# **Radcliff Elementary**

## **Project Closeout Update**

October 12, 2017

Image 2

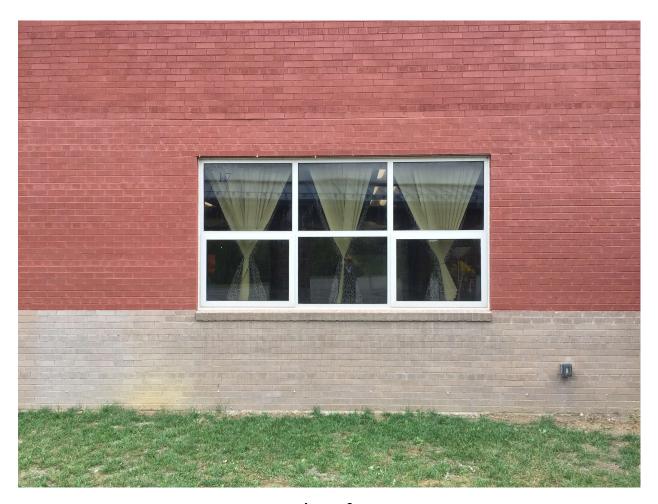
Existing brick infill has been removed and replaced at Classrooms 147, 148, 213, and 214. Brick stain has been completed and sealant has been applied around the perimeter of the windows
